Project Name: Anderson County Sports Training Facility File No.: J04

Date: November 10, 2023

This Addendum forms a part of the Construction Documents and modifies the original Documents dated October 17, 2023, as noted below. The items listed below shall supersede the previous information in the previously issued Bidding Documents and shall be incorporated into the entire Work described therein.

Fire Marshal Conditions Report Response(s):

LIFE SAFETY PLAN

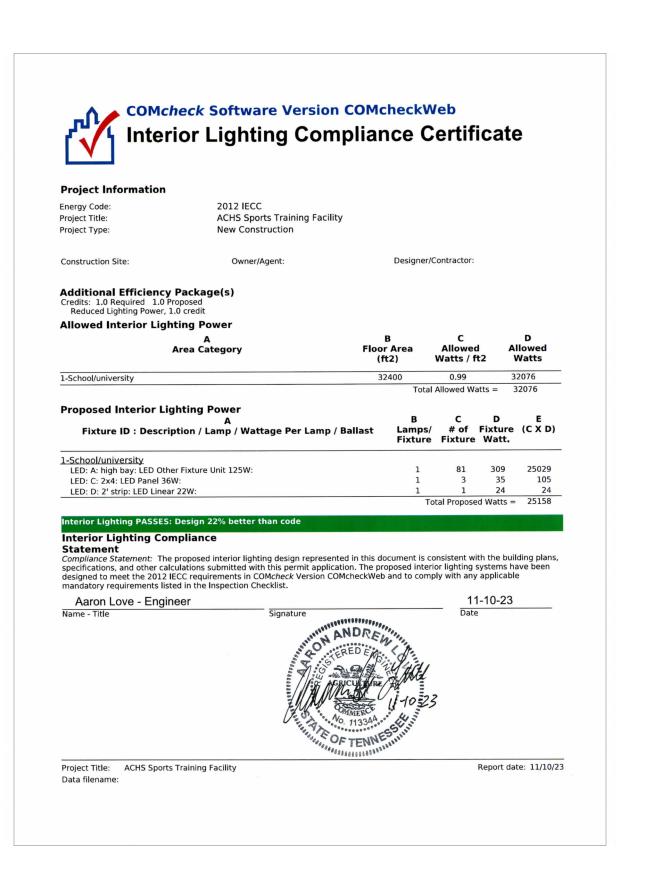
Review Comments: Please include the number of occupants at each exit and exit discharge. (Sheet: G099)

Response: life safety plan on G099 is revised to include number of occupants at each exit.

FP002
PROJECT DATE PROJECT NUMBER
2023-10-17 23030

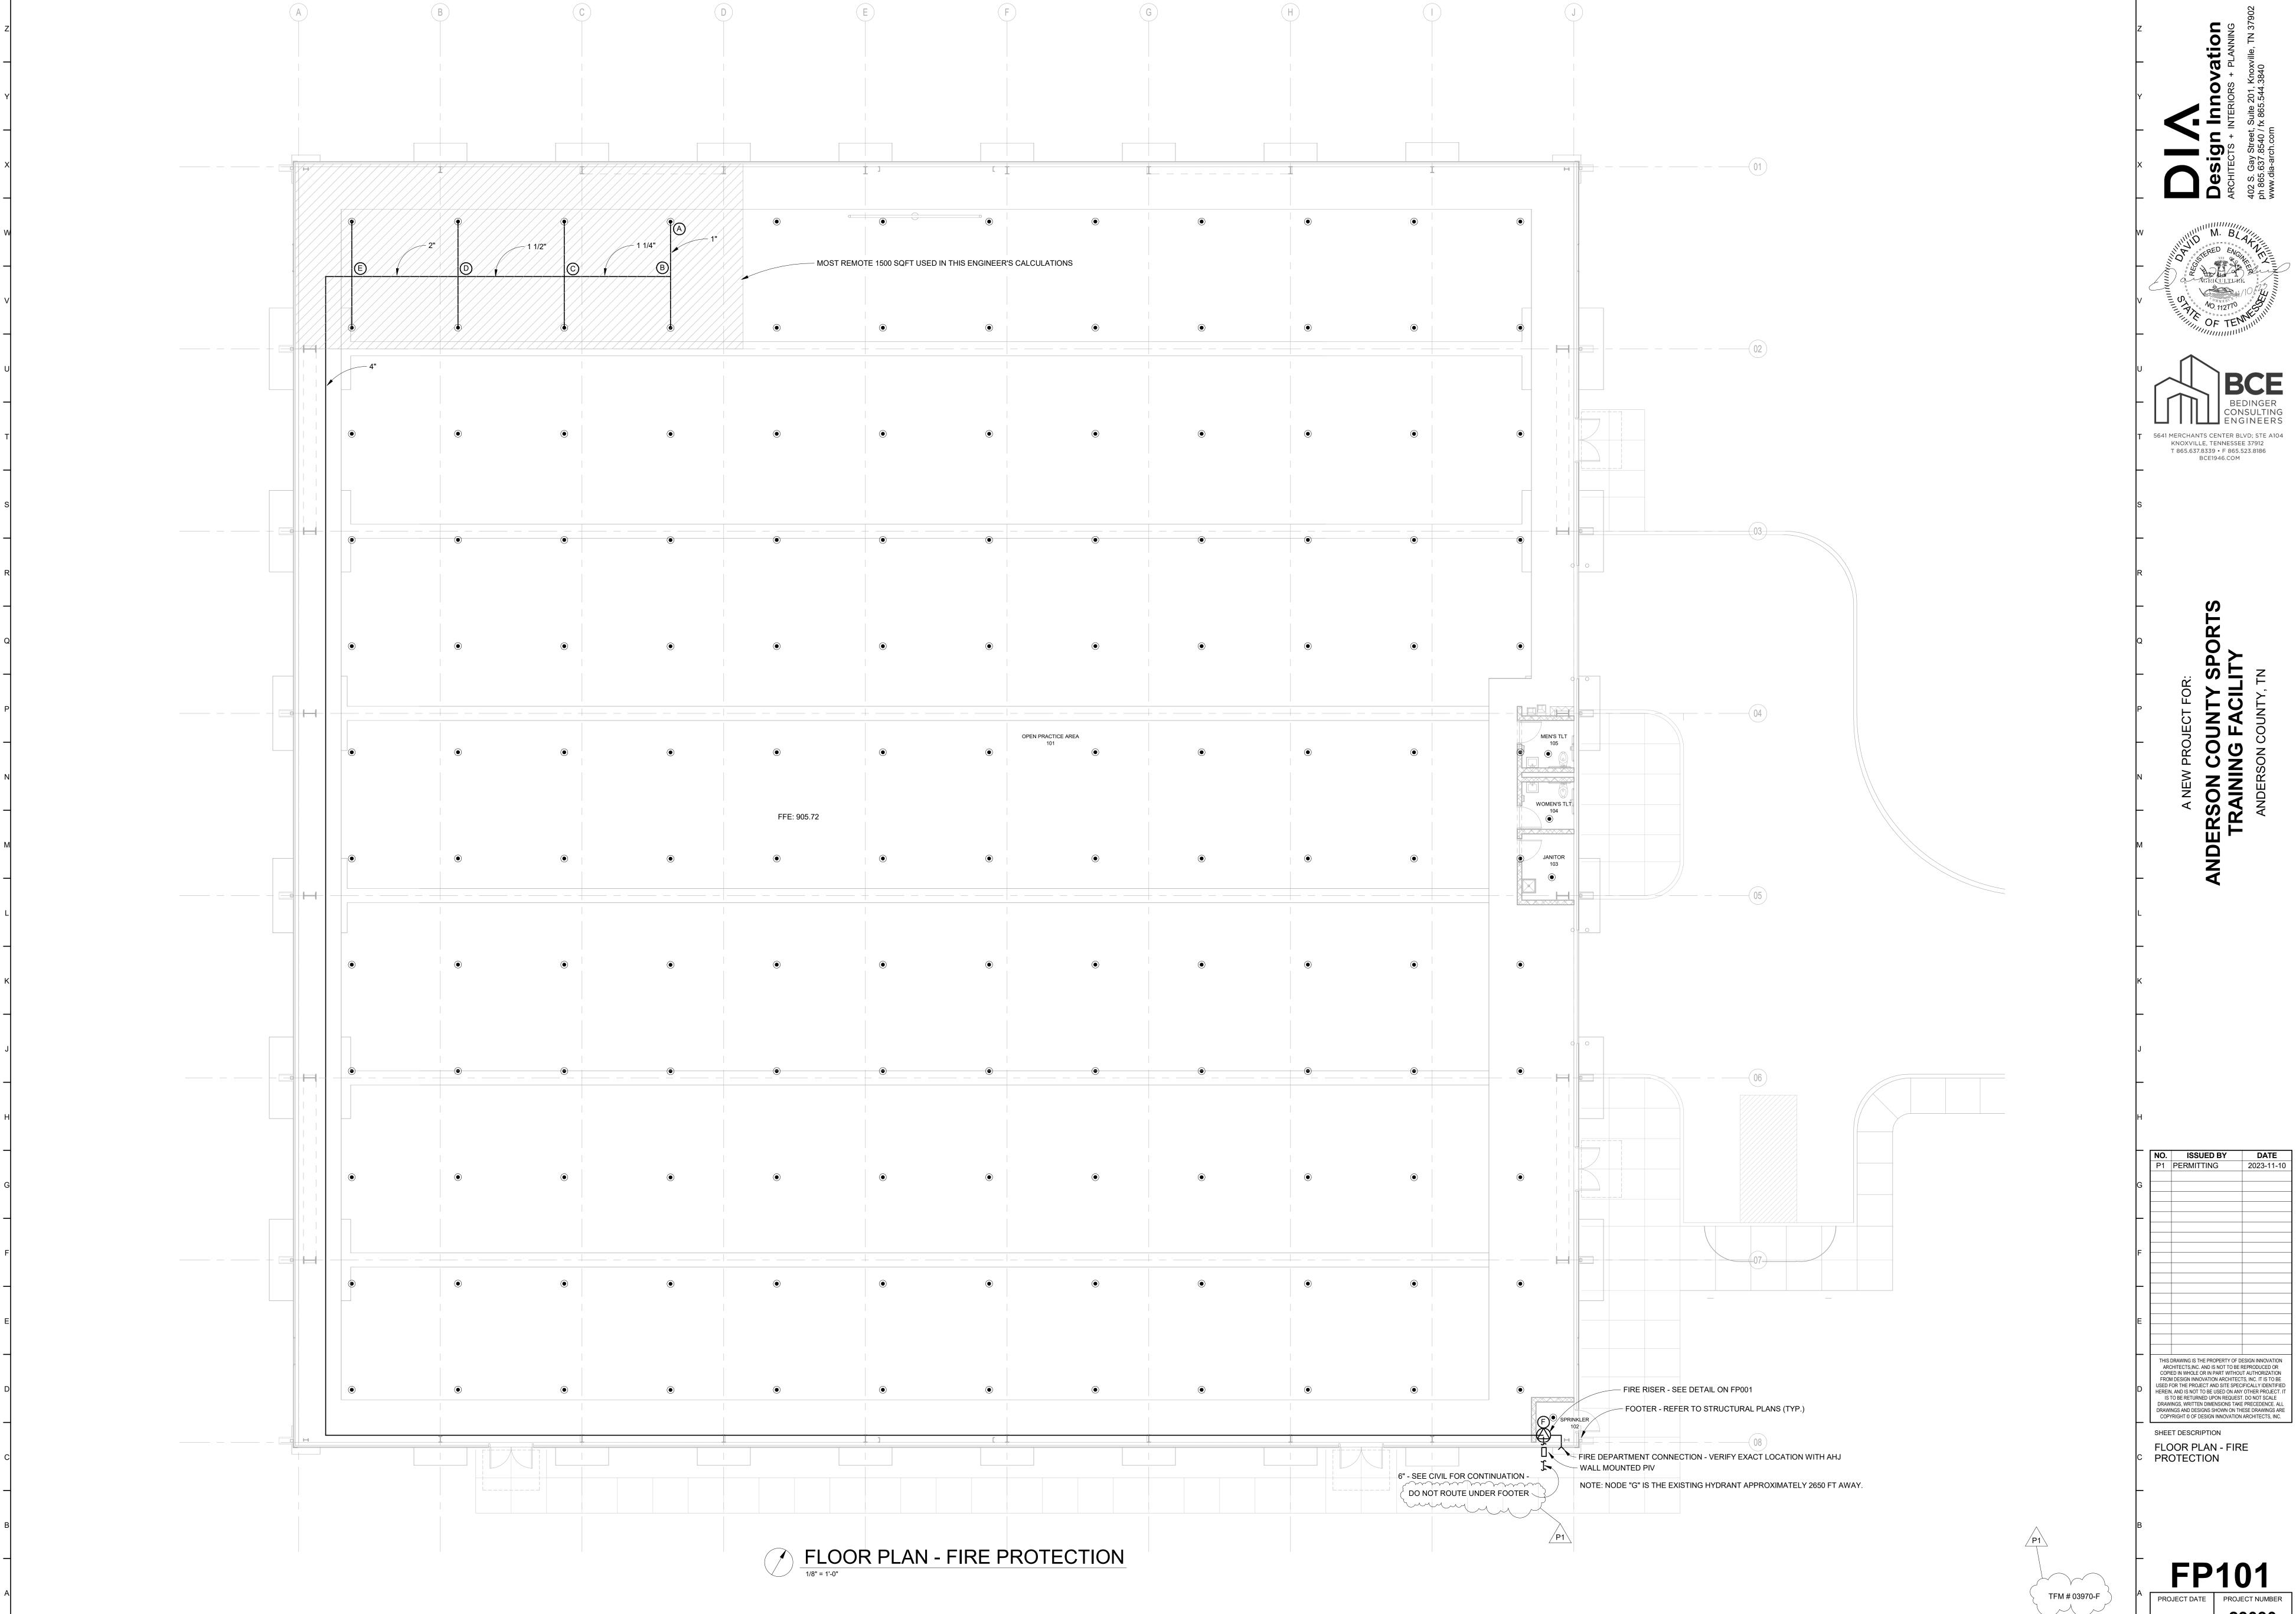
Review Comments: Janitor Room No. 103 must be Ordinary Group 1. (Sheet: FP101)

Response: please see fire protection specifications, #6, on FP002. The occupancy hazard classification is light hazard, and the Janitors Room No. 103 is ordinary hazard group 1.
